January 5, 2026

First Covenant Church Lobby & Fellowship Addition – JGR Proj #25-3518

ADDENDUM NO. 2

JCR
JonesGillamRenz
730 N. Ninth
Salina, KS 67401
1881 Main Street, Suite 301
Kansas City, MO 64108
785.827.0386
jgr@jgarchitects.com

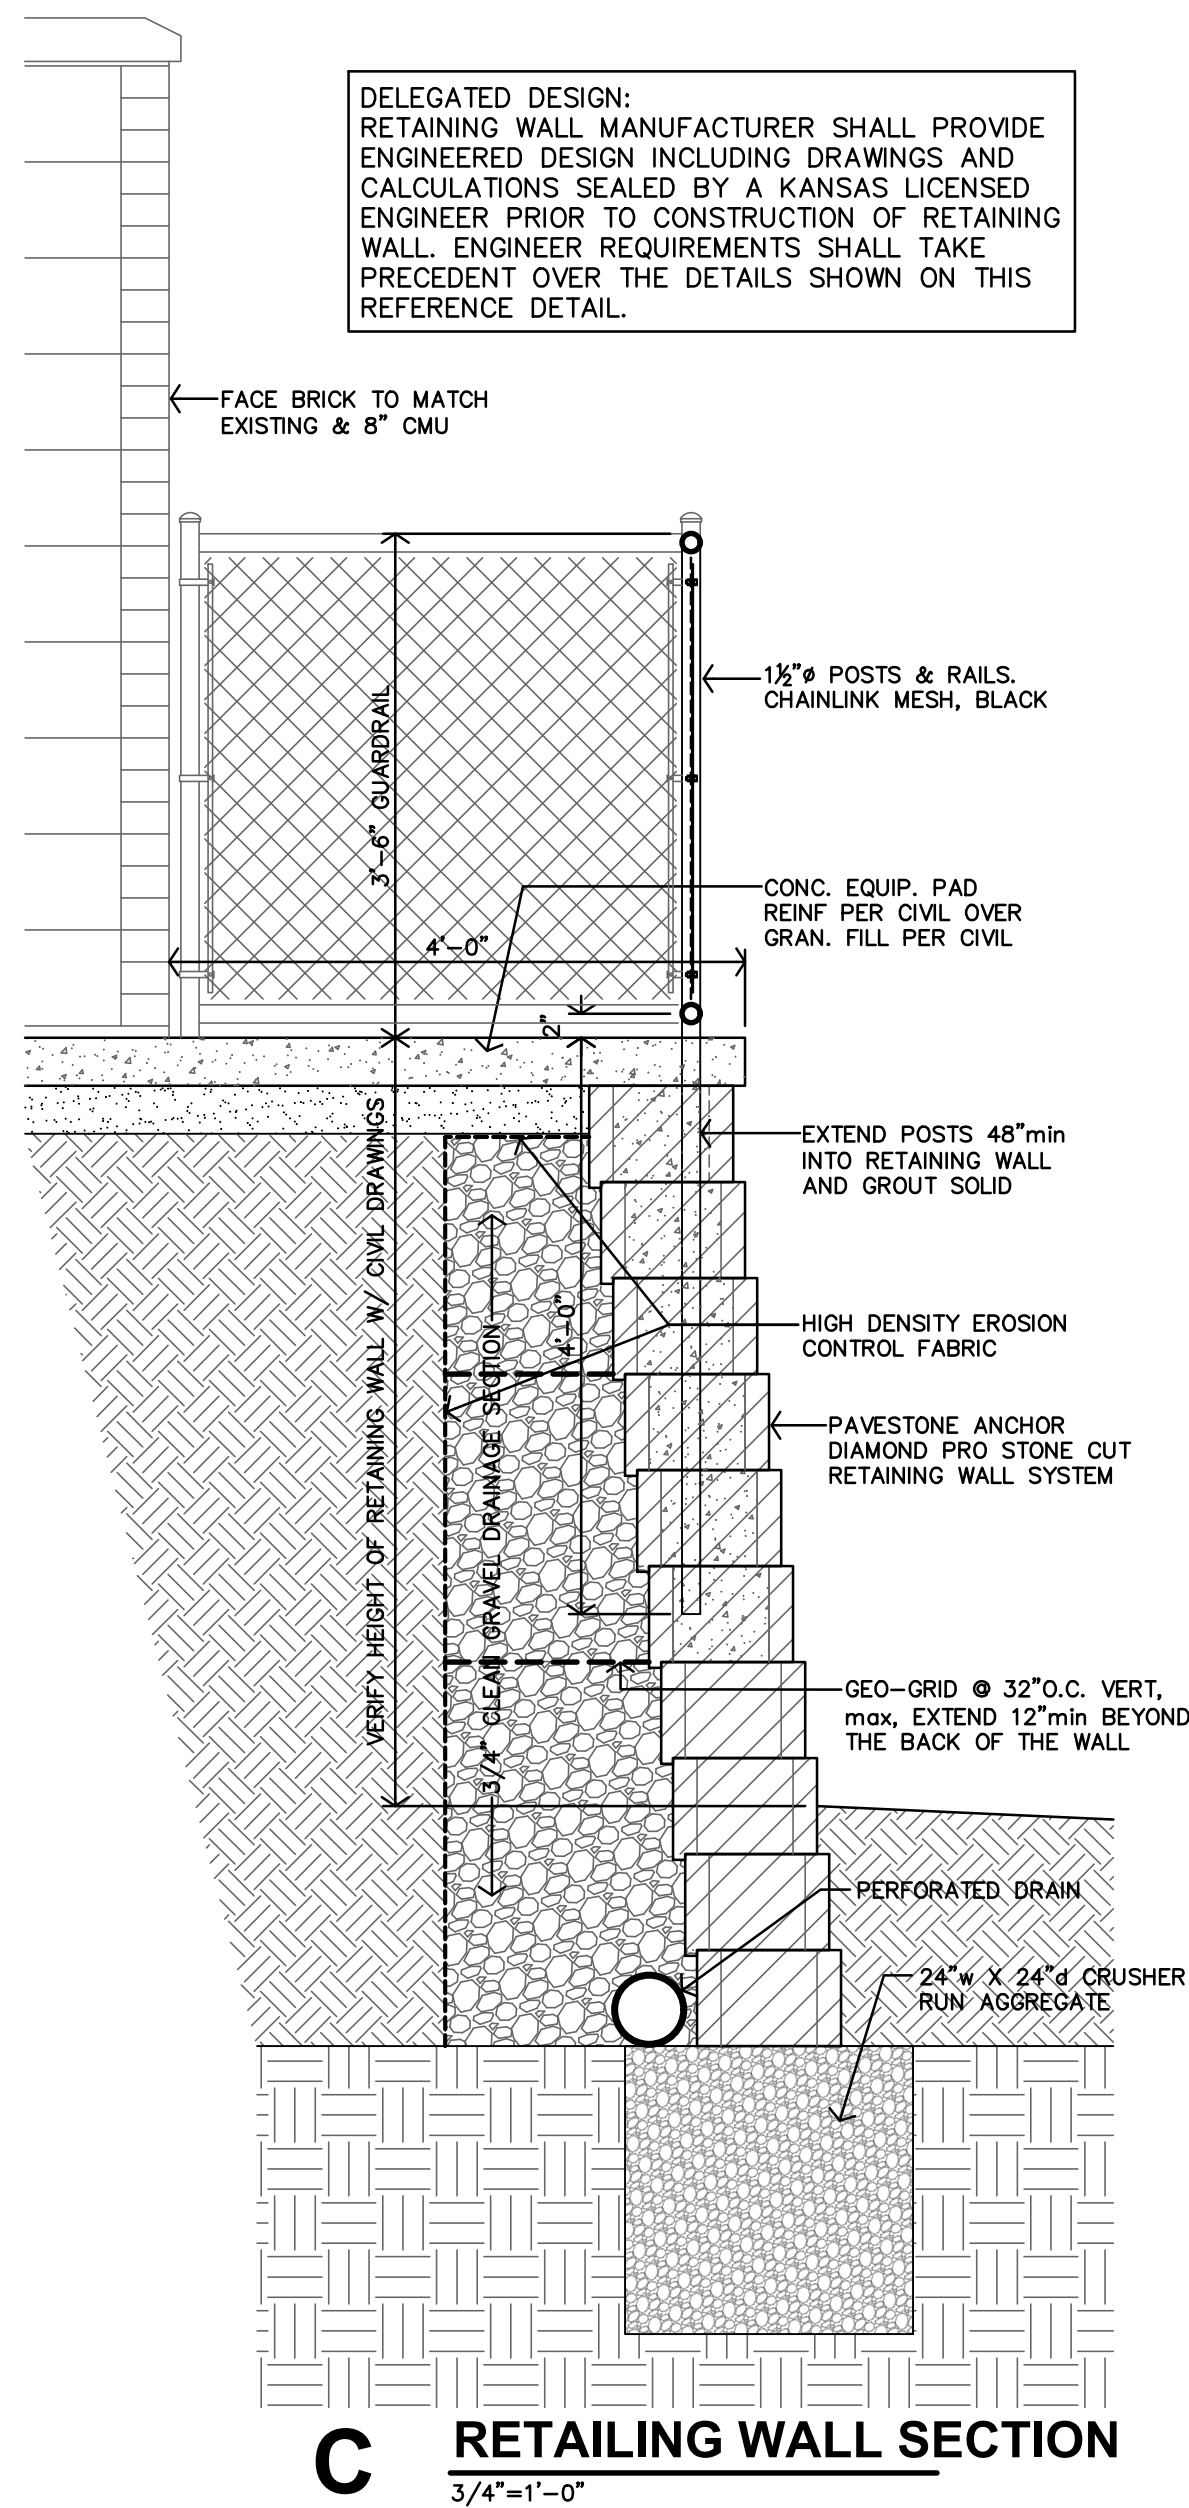
4. Sheet A4.3 – Wall Section A and Section AA (new) – Reference revised drawing sheet attached with this addendum for clarification regarding ductwork penetration and transition at the NW corner wall penetration.

5. Sheet A4.3 – Building Section D – Reference revised drawing sheet attached with this addendum for clarification regarding the masonry wall/retaining wall at the west side of the building. Brick and CMU shall extend down to the footing as shown on structural drawings.
